Re: St. Edna Catholic Church  
2525 N. Arlington Heights Road  
Arlington Heights, Illinois 60004

Subject: **Plan Commission Review Comments for St. Edna Catholic Church (2525 S. Arlington Heights Road, Arlington Heights, IL 60004)**

This letter is in response to the Plan Commission Comments received on September 14, 2017 and September 21, 2017. See revised drawing sheets dated Plan Commission Resubmittal #1 9/25/2017 and the itemized letter below.

ORDERED BY:  
SEAN FREEDS  
Vice. of ARLINGTON HTG.  
9/6/13

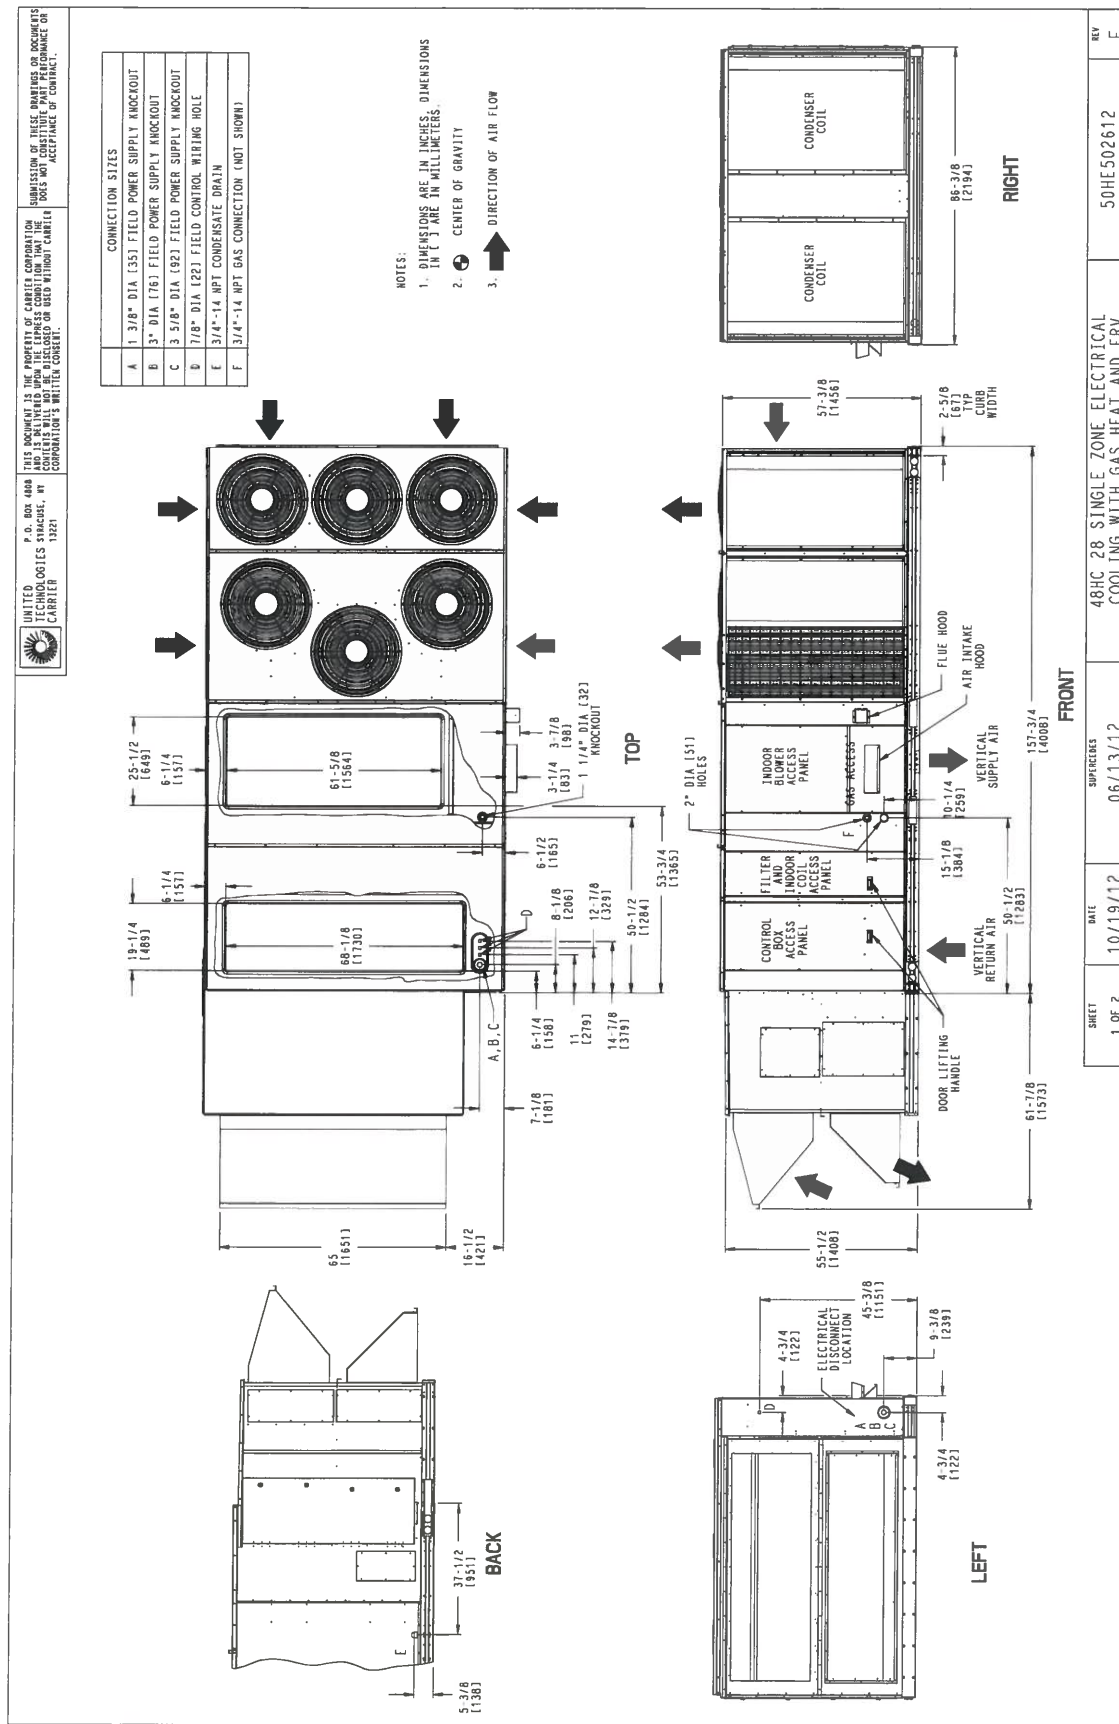
1. The existing well must be properly abandoned by a licensed contractor and witnessed by this Department.  
*The well has been abandoned and sealed. This activity was observed by Sean Freres from the Village of Arlington Heights on September 6, 2013. See form included as a part of this response package and included as **EXHIBIT D**.*
2. Parking lots with 301 to 400 parking spaces requires a minimum of eight (8) Accessible Parking Spaces per IAC Section 400.310(c)(1). In accordance with the requirements of IAC section 400.310(c)(2 and 3).  
*As indicated on the Existing Site Plan as well as the Proposed Site Plan, St. Edna currently has 11 Accessible Parking Spaces – 6 on the Southeast edge of the parking lot and 5 just west of the existing Church. St. Edna will continue to designate these spaces for Accessible Parking only.*

Certified Drawing for RT-1

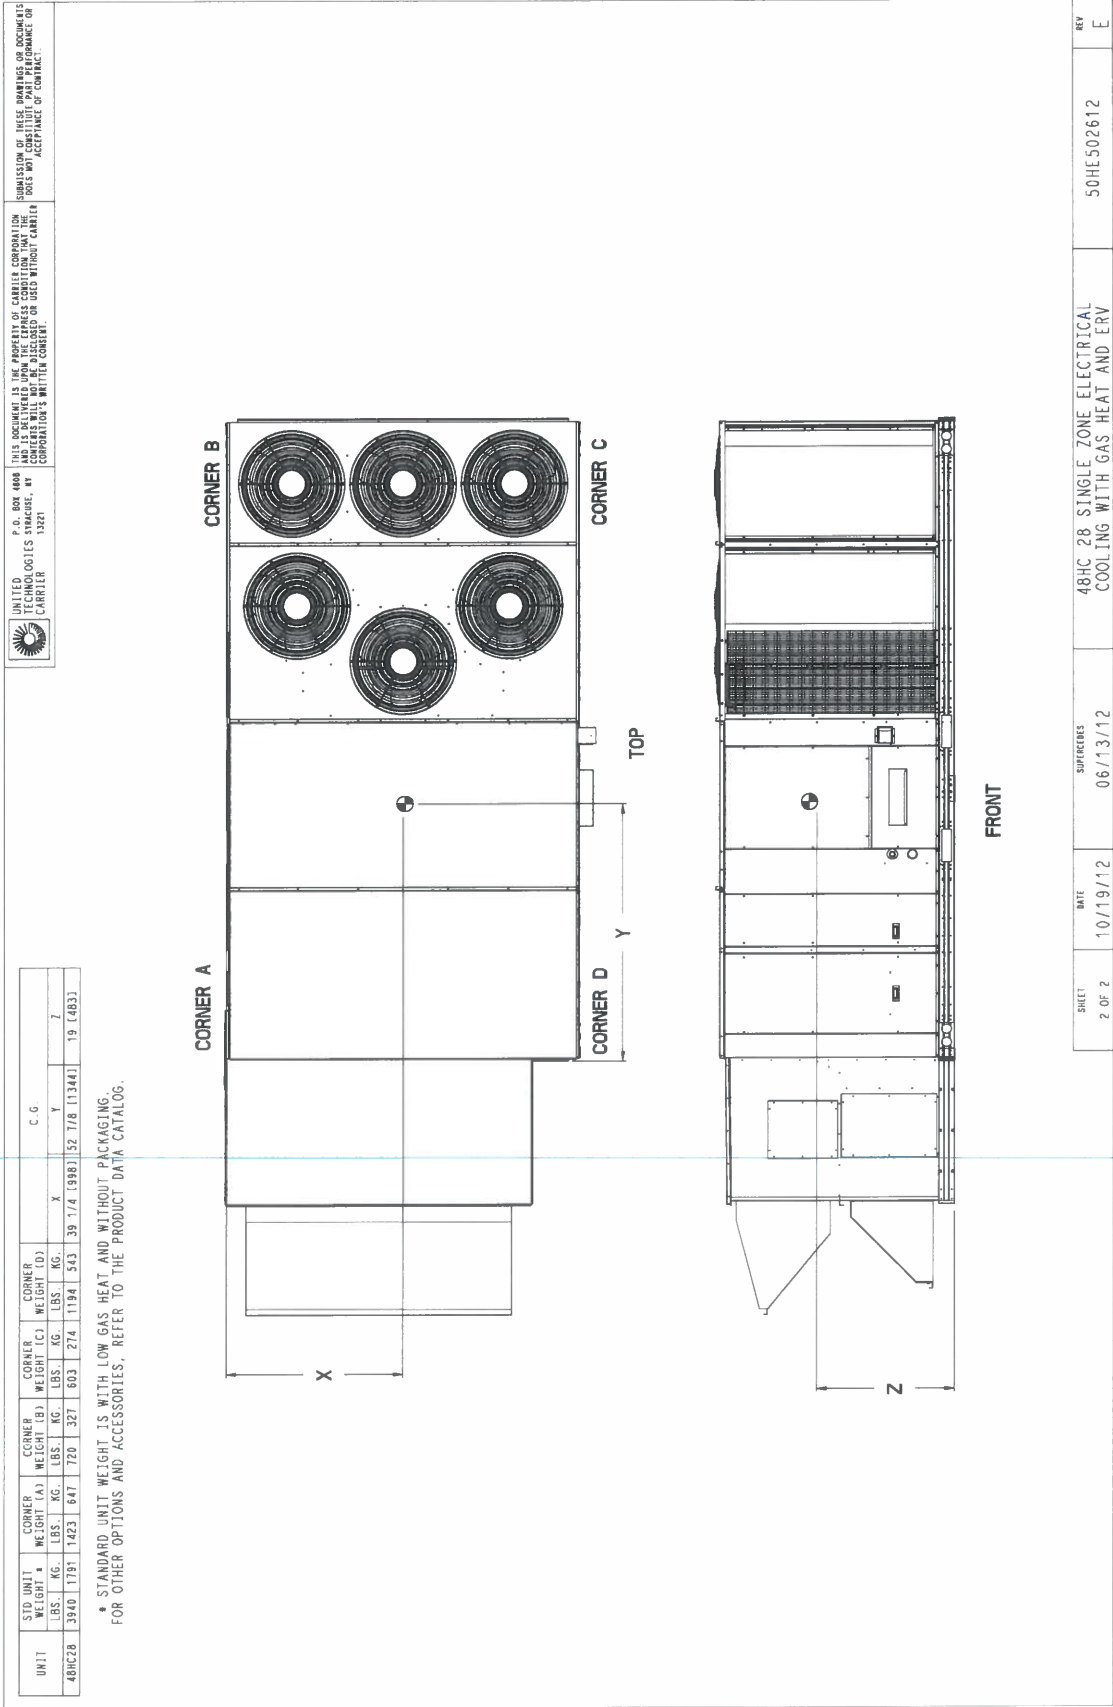
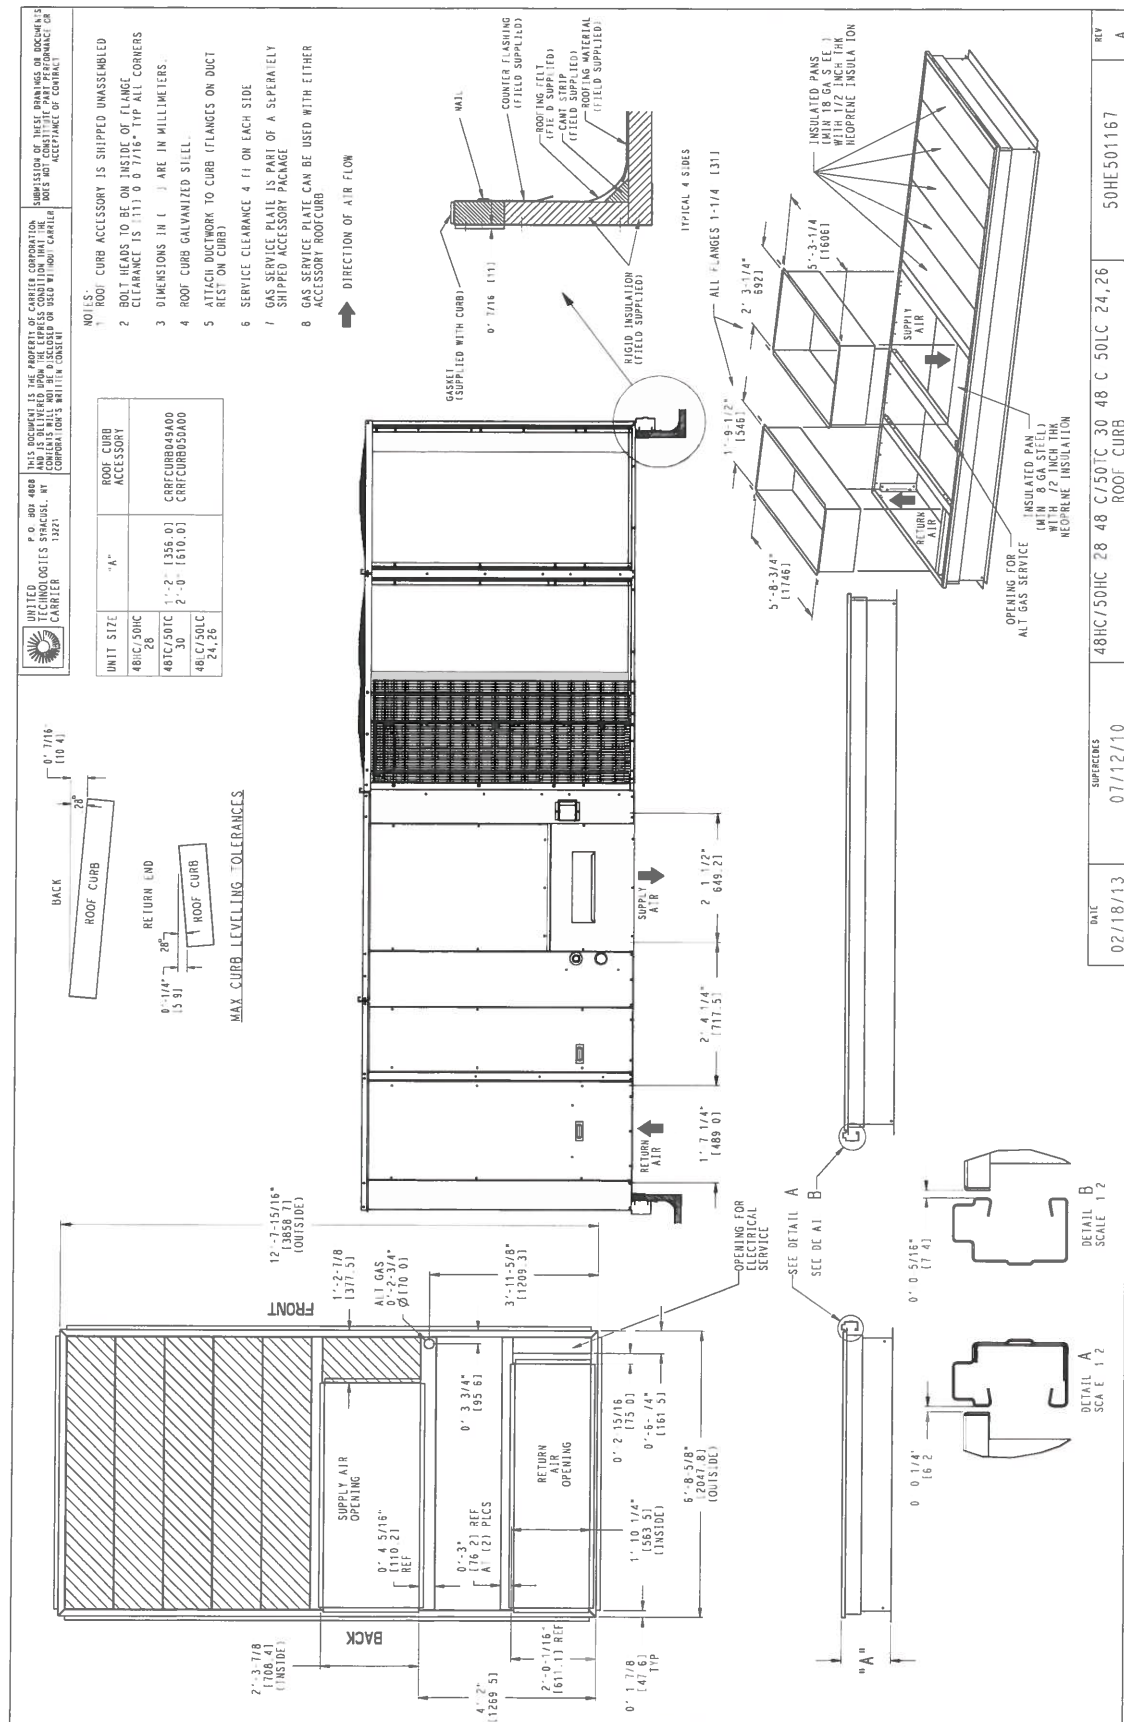
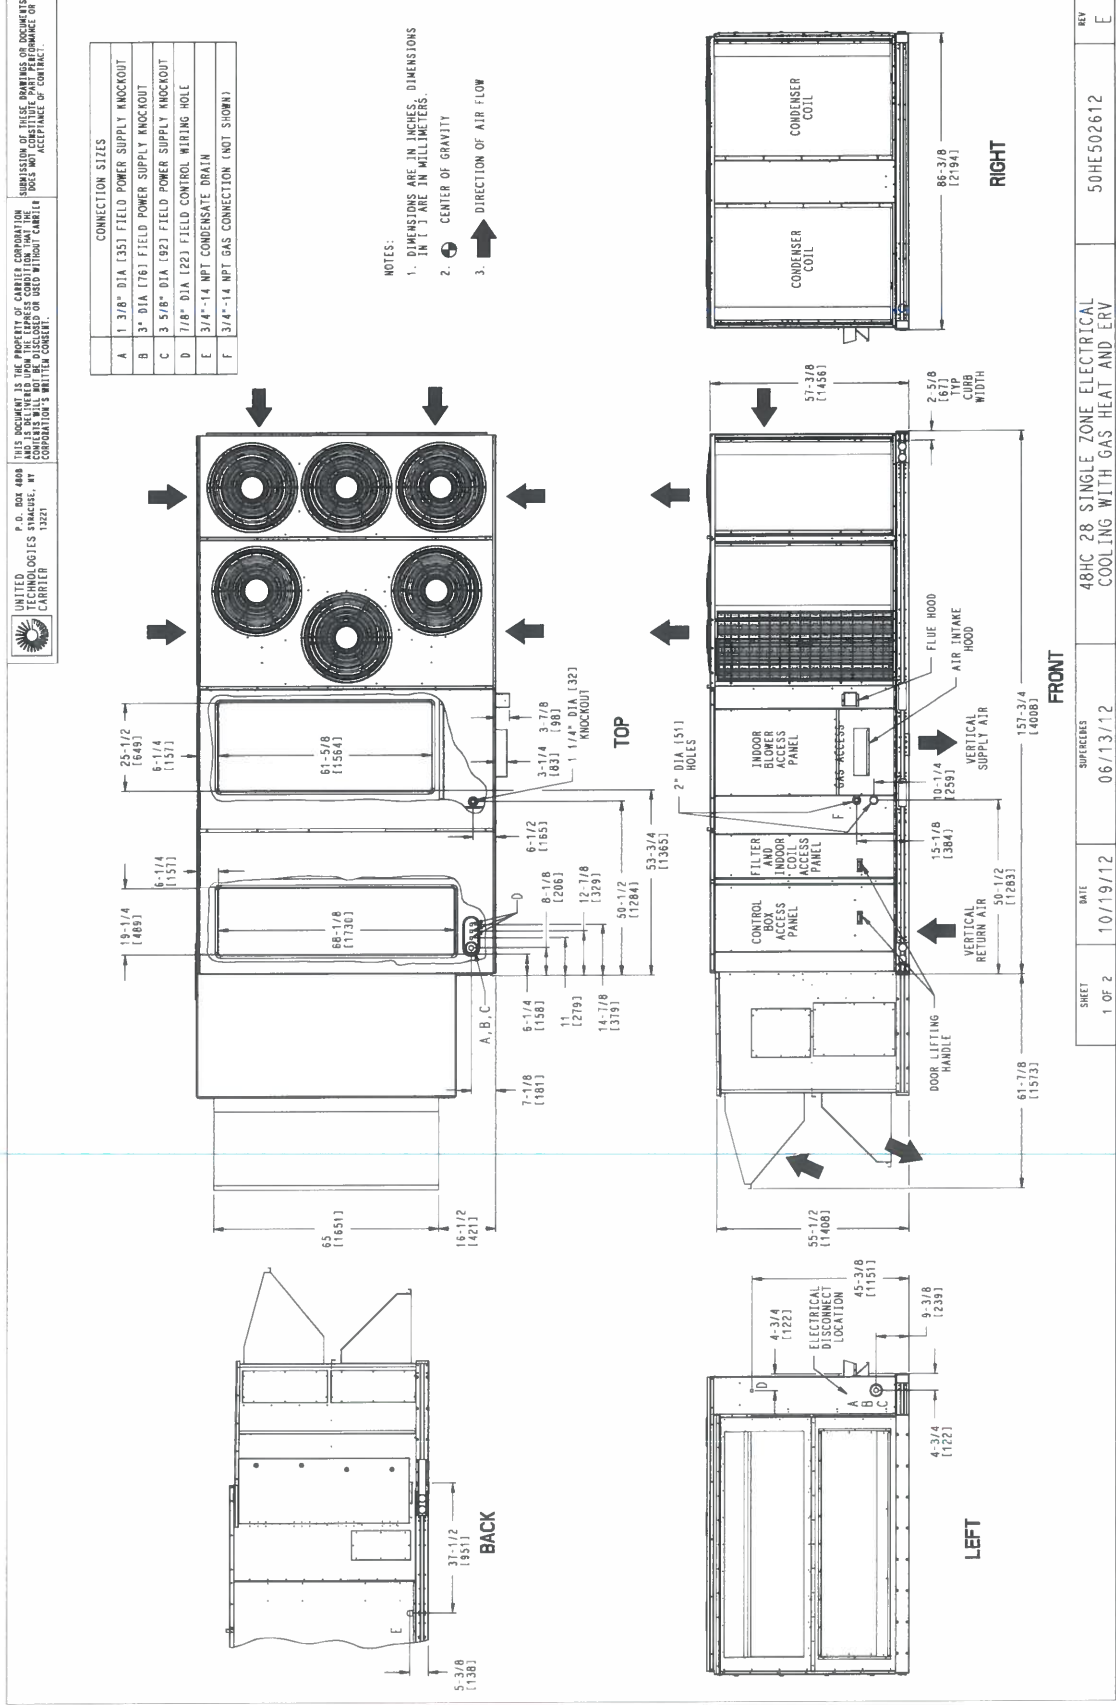
10. Please provide additional information on the 3 proposed HVAC units. Will they all be the 20 ton Carrier grade units as indicated in 2013? How tall are the units? Will the proposed fence and

landscaping be adequate to buffer the sound? The proposed fence around the units is 8' in height, is the 8' tall fence needed to fully screen the unit?

*RTU-1: North East location: 25 tons; RTU sits on a 36" high curb. The unit is 57 3/8" for a total height of 7'-9 3/8".*

*RTU-2: South East location: 25 tons; RTU sits on a 36" high curb. The unit is 57 3/8" for a total height of 7'-9 3/8".*

*RTU-3: North West location: 10 tons; RTU sits on a 14" curb. The unit is 49 3/8" for a total height of 5'-3 3/8".*

*Given the heights listed above, an 8'-0" fence is required for RTU-1 and RTU-2 in order to fully screen the unit. The precast screen wall on the north side of RTU-3 is taller than required to screen that unit, but blends with the architecture of the adjacent building. The fence on the east of RTU-3 has been reduced to a 6'-0" high fence.*
